**RE: Application of Columbia Gas of Ohio, Inc. for a  
Certificate of Environmental Compatibility and  
Public Need for the Construction of the Ackerman  
Road Natural Gas Pipeline Project  
Ohio Power Siting Board Case No. 11-3534-GA-BTX**

Please accept this correspondence for filing in the public docket in the above-captioned proceeding. This correspondence provides information on certain adjustments to the pipeline location for the Ackerman Road Natural Gas Pipeline Project.

Attached to this correspondence are two engineering drawings showing the realignment as described above. We have received permission from OPSB Staff to treat this change as an engineering adjustment since the realignment involves a slight shift (~25') in the currently certified route.

SHEET NO. 12

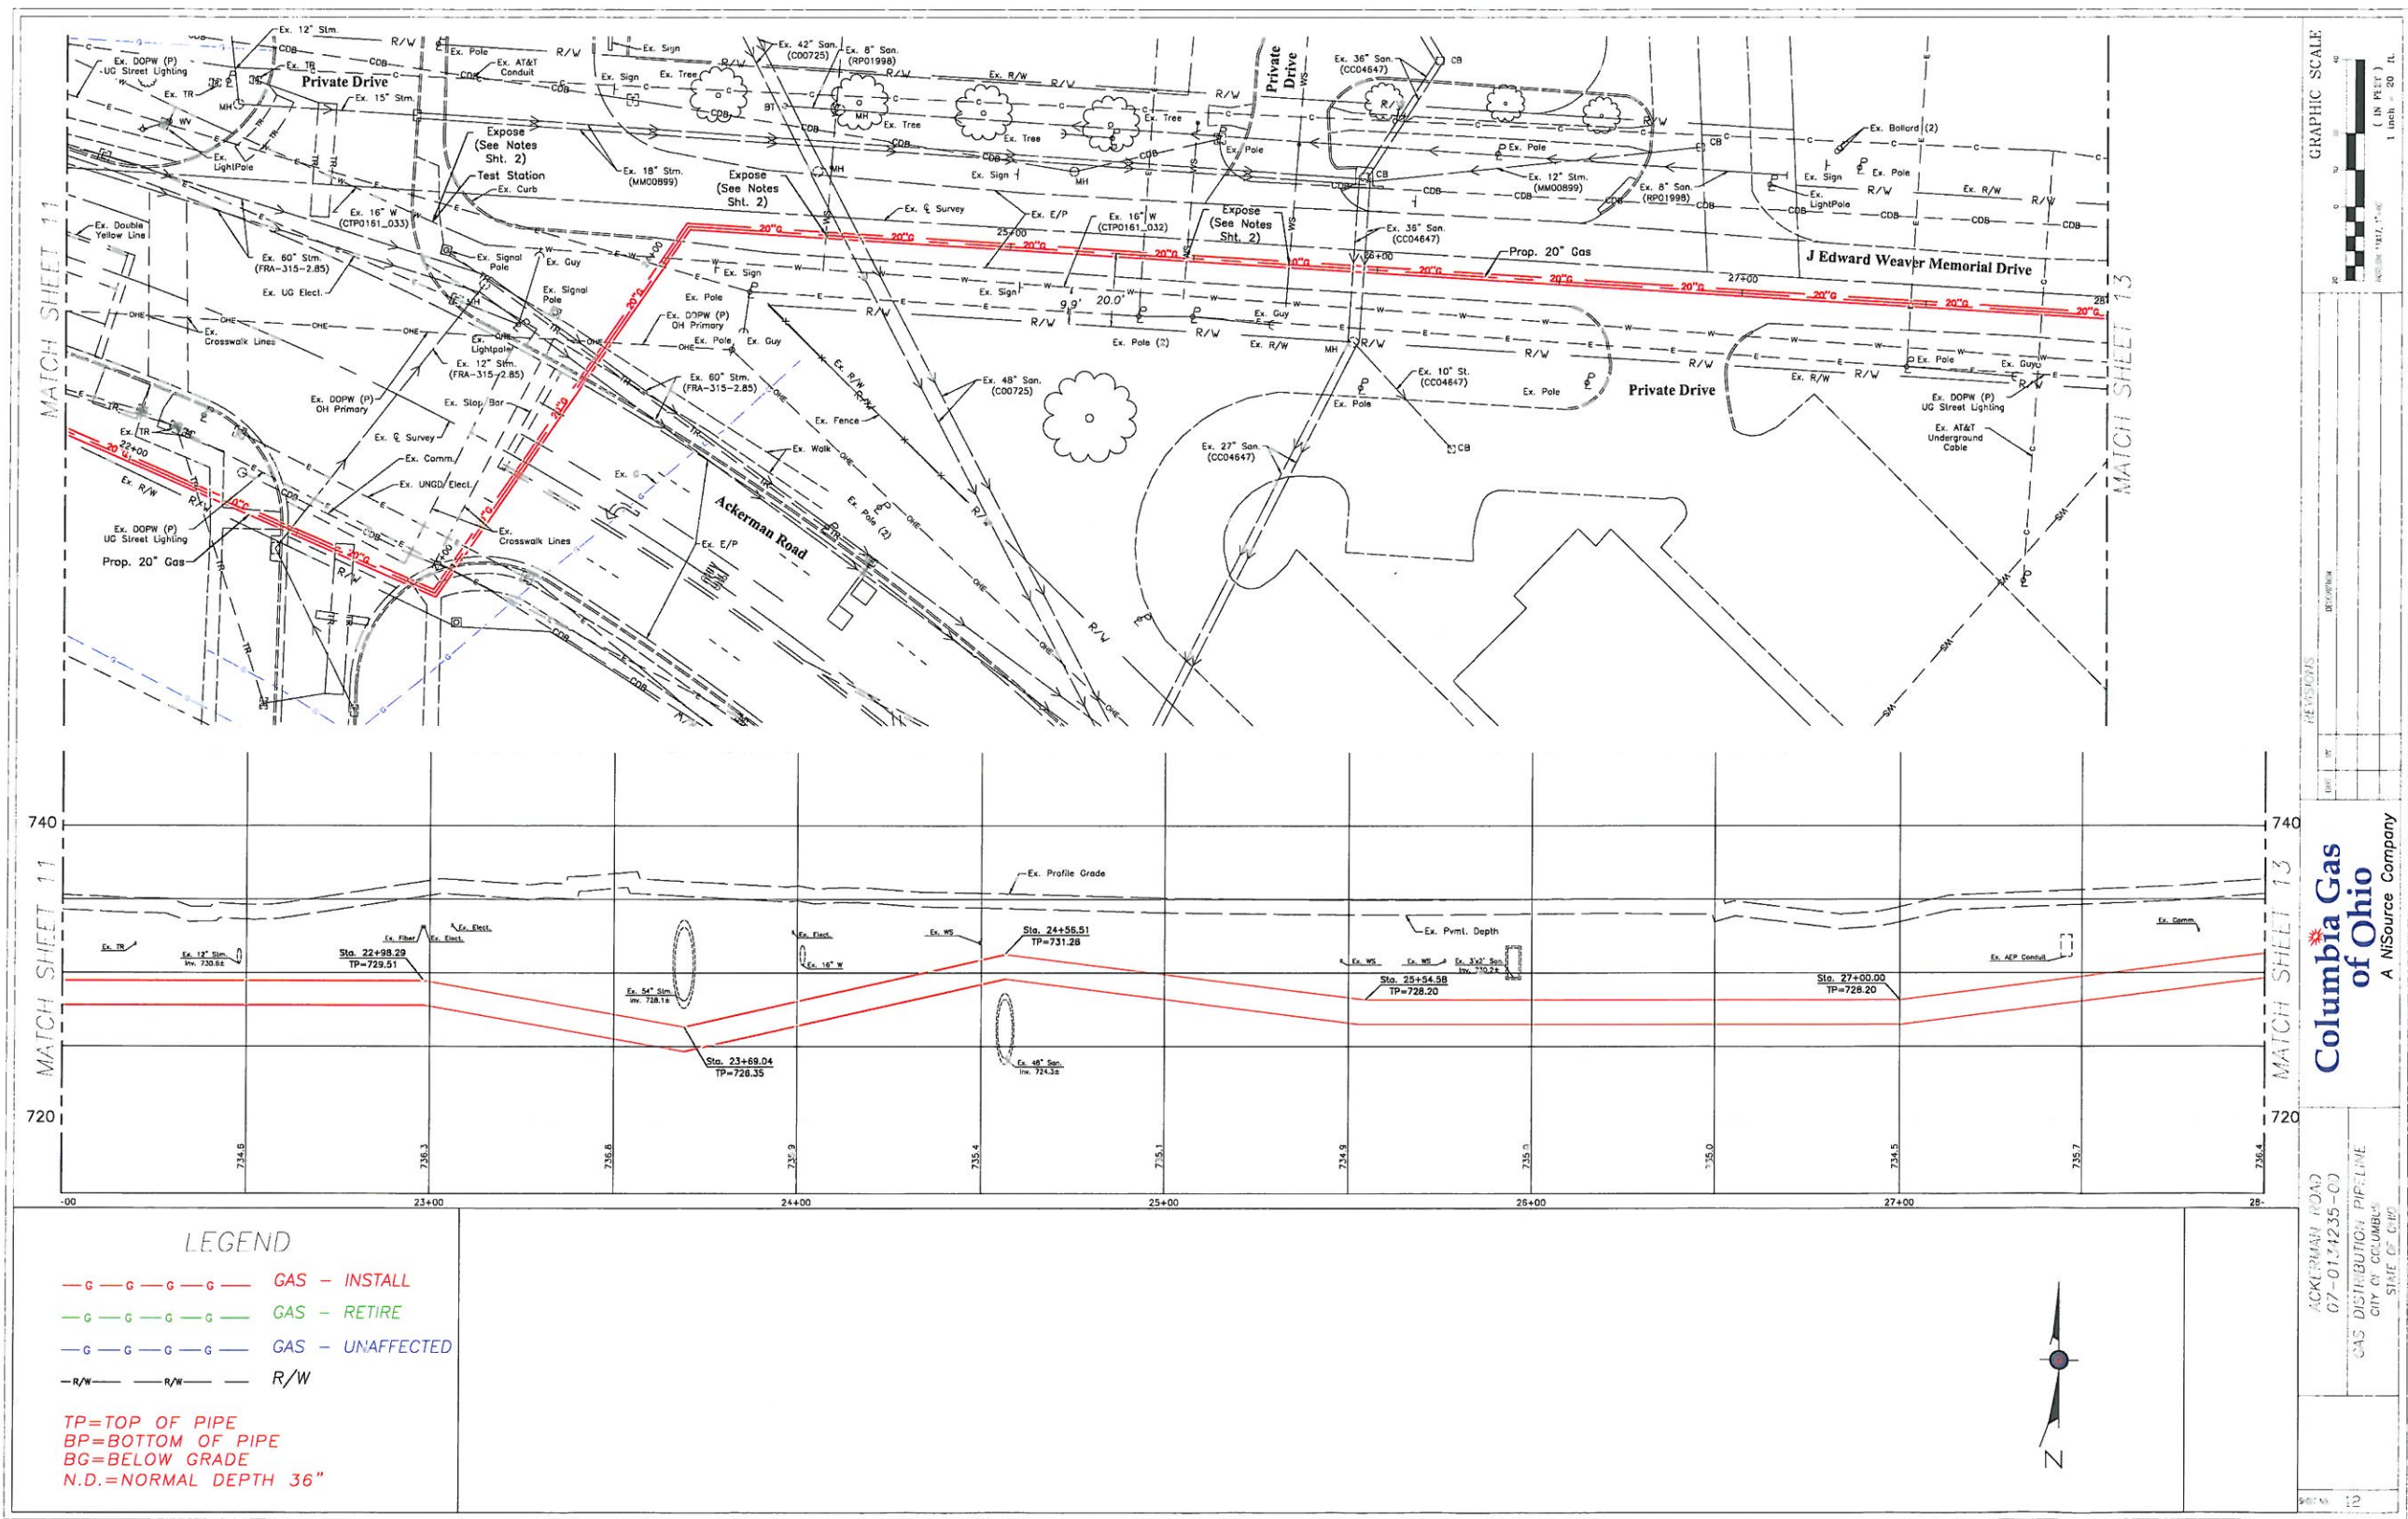
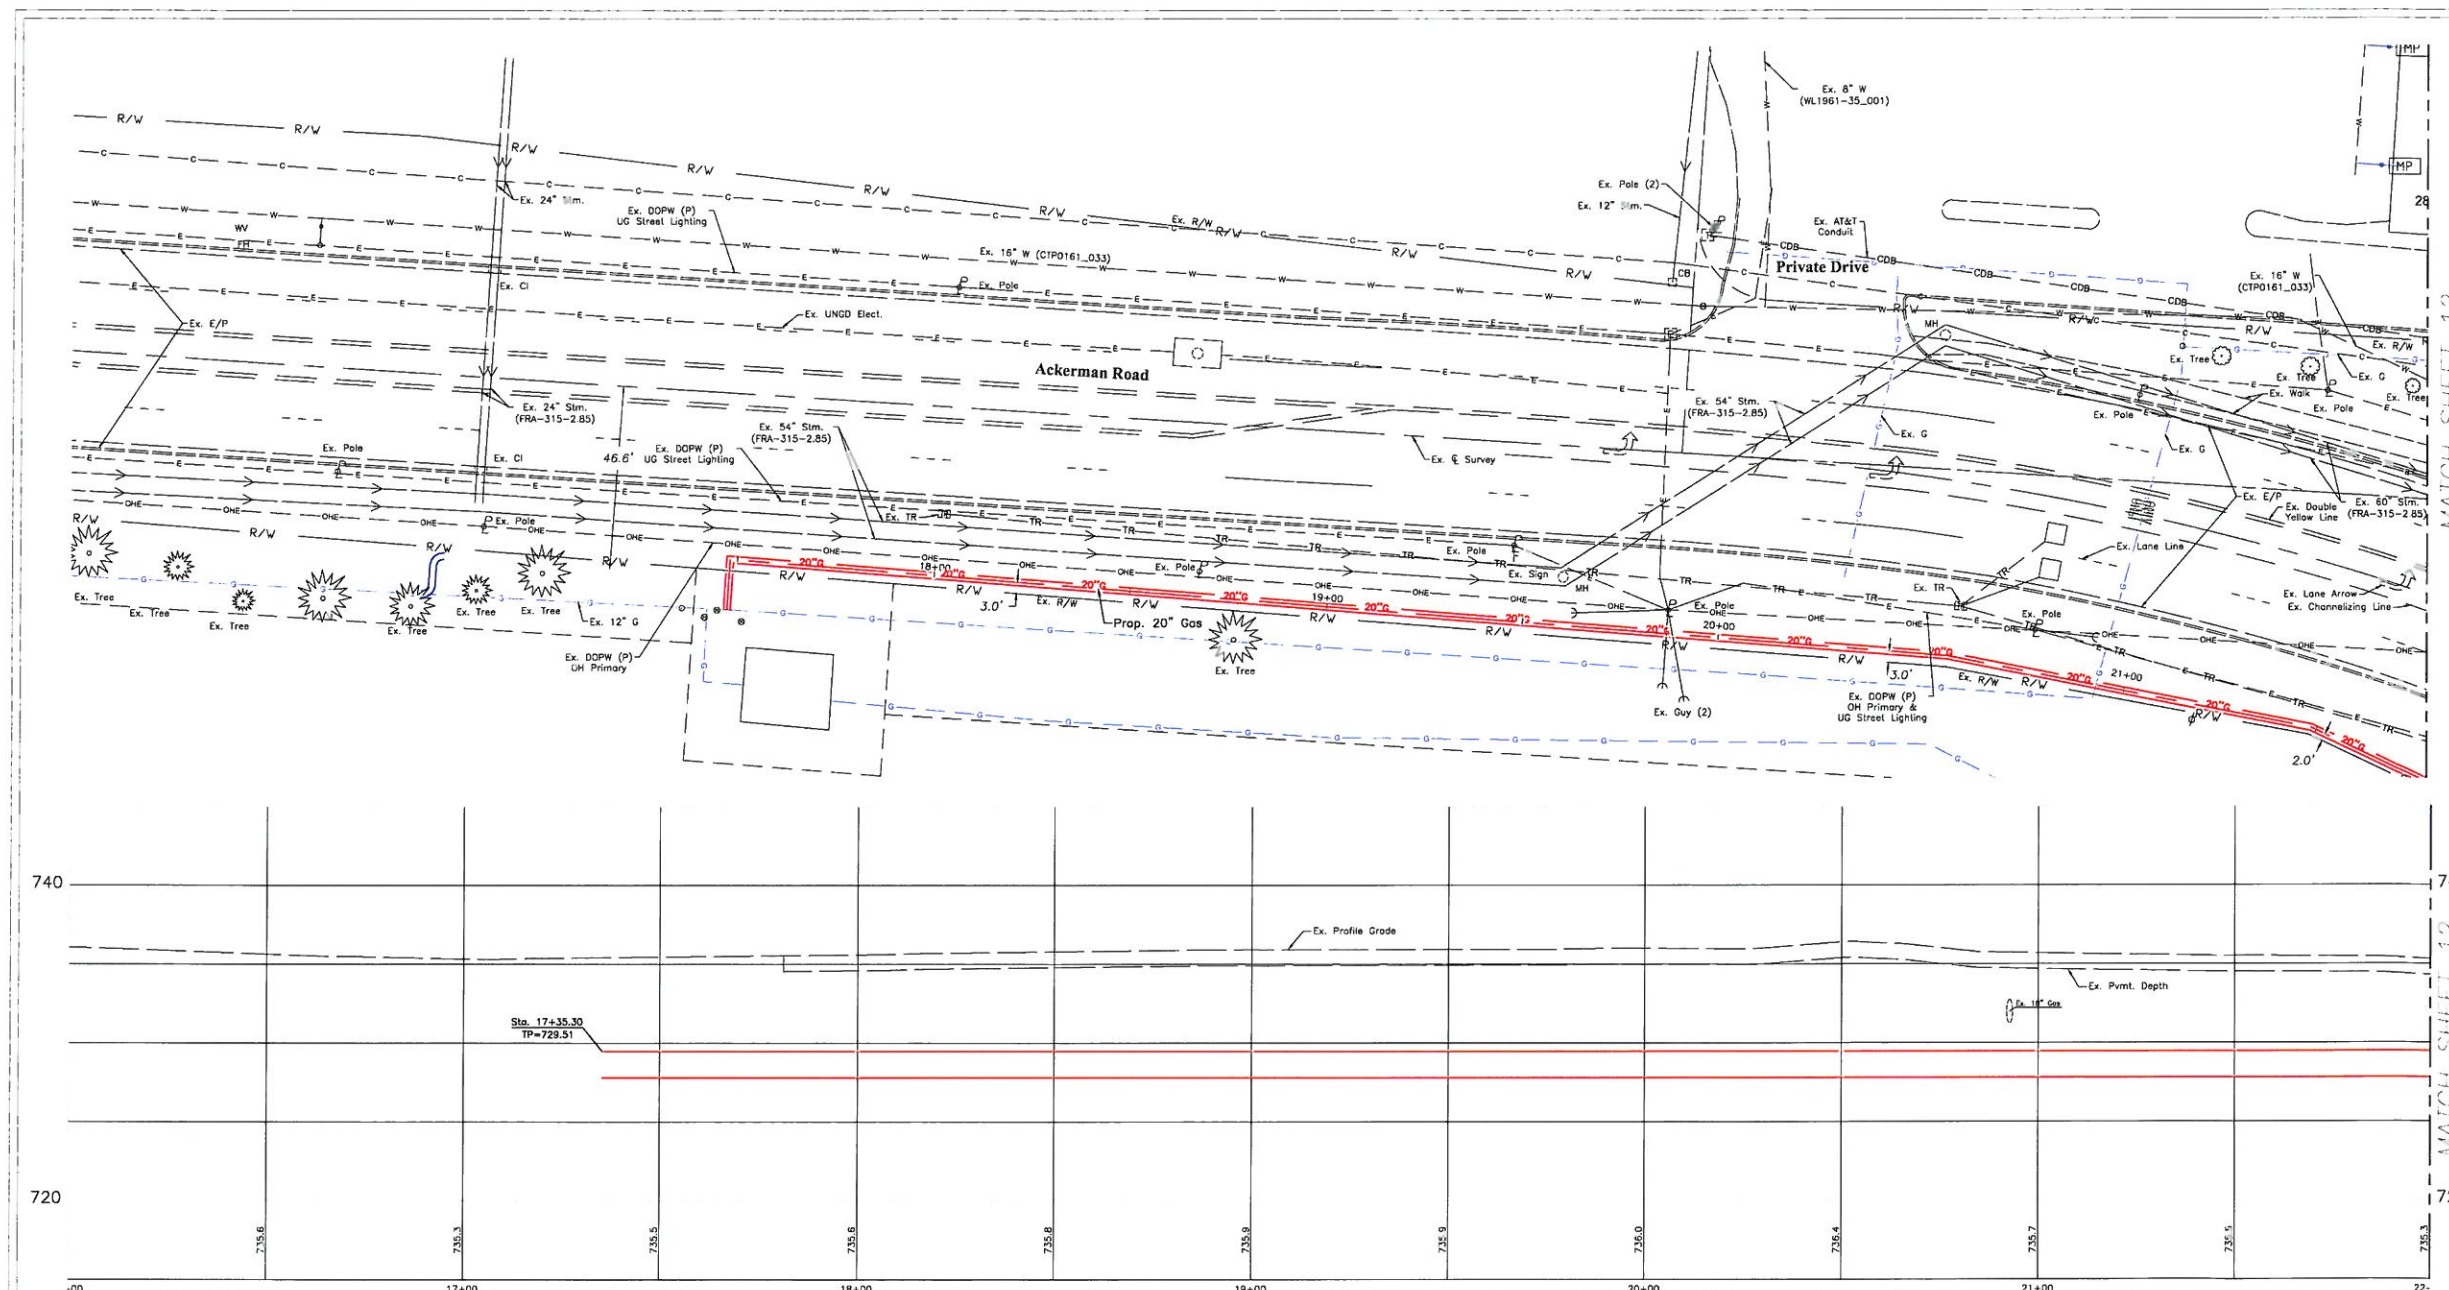
Construction is underway on the Ackerman Road Pipeline Project. In constructing the portion of the gas pipeline in Ackerman Road, it has been determined that it is possible to install that portion of the project outside the pavement portion of the Ackerman Road right-of-way (row) utilizing the unpaved area of the row. By doing so, the disruption to traffic flow along Ackerman Road, and its consequent impact to the traveling public, can be minimized. This will necessitate an additional road crossing of Defiance Dr. which will allow Columbia Gas to eliminate impacts on the City's traffic signals in that area.

The current plan is to install the pipeline crossing of Defiance Dr. one lane at a time in order to maintain traffic flow. This plan is dependent upon the City of Columbus maintenance of traffic (MOT) requirements. However, there is another entrance to the apartment village in the event that the City requires that Columbia Gas close Defiance Dr. during construction.

These adjustments will limit impacts to the City's existing infrastructure, and also reduce impacts to the motoring public on Ackerman Road, since the pipeline will not be placed in the pavement along Ackerman Road. Because of the urban nature of this area, there are no permanent or temporary impacts to any environmental, historic, cultural or recreational resources.
